License to Operate On-Site Sewage Treatment and Disposal Facility

2719 GLENN DR

OTT RESIDENCE

PLANNING MATERIALS FOR A SEPTIC SYSTEM IN COMAL COUNTY

Revision of 6 Feb 2020

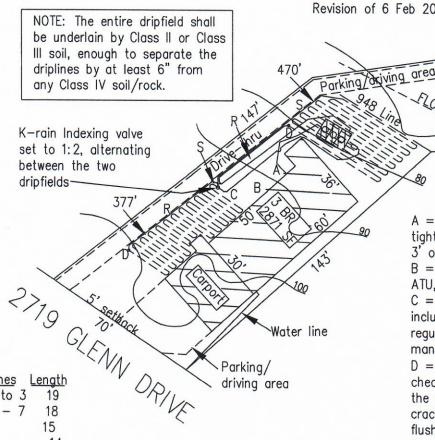
Tanks in front of garage cloop.

Hos 8' wide concrete walk on side

of House. Need Revised Plan on foot

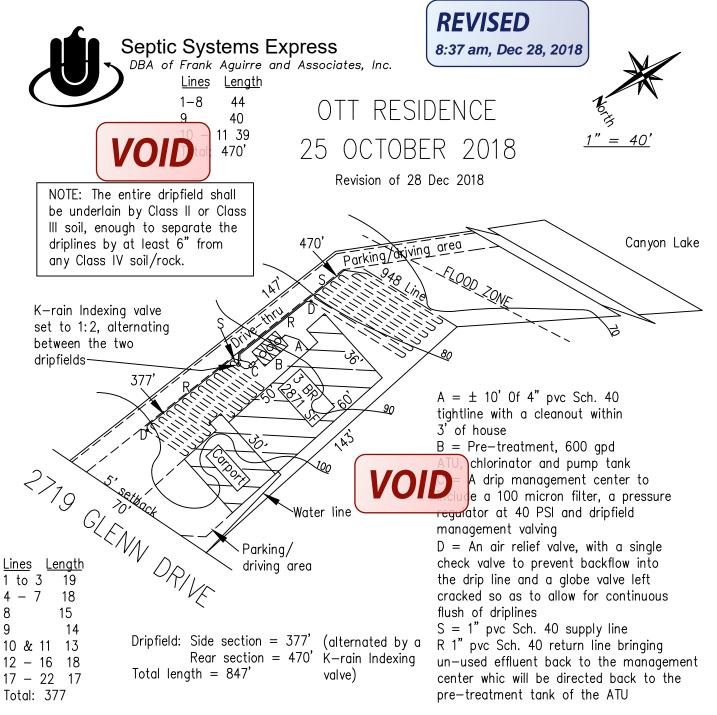
We received planning materials for the referenced permit application on December 6, 2018 and found those planning materials to be deficient. In order to continue processing this permit, we need the following information:

Show the floodplain location of the property on your site plan.

- 4. Dimension every dripline on your design.
- 5. Revise accordingly and resubmit to our office.
